Reference: C.N.539.2001.TREATIES-1 (Depositary Notification)

REGULATION NO. 50. UNIFORM PROVISIONS CONCERNING THE APPROVAL OF FRONT POSITION LAMPS, REAR POSITION LAMPS, STOP LAMPS, DIRECTION INDICATORS AND REAR-REGISTRATION-PLATE ILLUMINATING DEVICES FOR MOPEDS, MOTOR CYCLES AND VEHICLES TREATED AS SUCH

TRANS/WP.29/781

DRAFT SUPPLEMENT 4 TO REGULATION No. 50

"Front position lamps (for a pair of lamps)

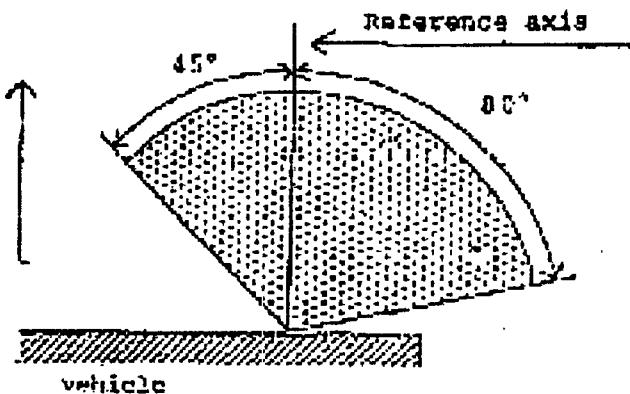
Paragraph 1. insert a new figure to read:

$V = +15^\circ / -10^\circ$

"Rear position lamps (for a pair of lamps)

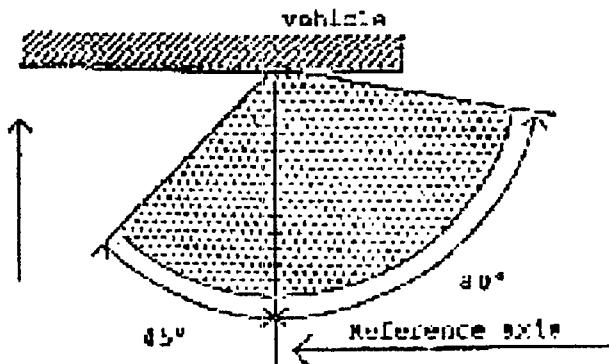
Paragraph 2. insert a new figure, to read:

$V = +15^\circ / -10^\circ$

"3. Direction indicators of categories 11, 11a, 11b, 11c and 12

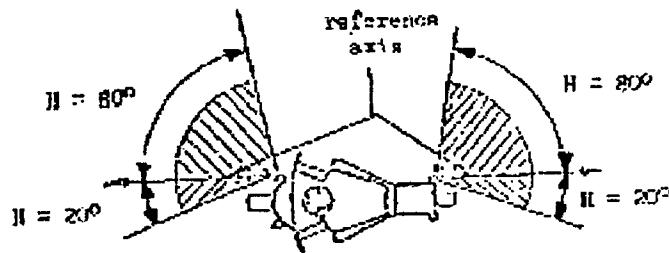
Paragraph 3., amend to read:

$$V = \pm 15^\circ$$

Minimum horizontal angles of light distribution in space:

Categories 11, 11a, 11b and 11c: direction indicators for the front of the vehicle;

Category 11: for use at a distance not less than 75 mm from the passing beam headlamp;

Category 11a: for use at a distance not less than 40 mm from the passing beam headlamp;

Category 11b: for use at a distance not less than 20 mm from the passing beam headlamp;

Category 11c: for use at a distance less than 20 mm from the passing beam headlamp.
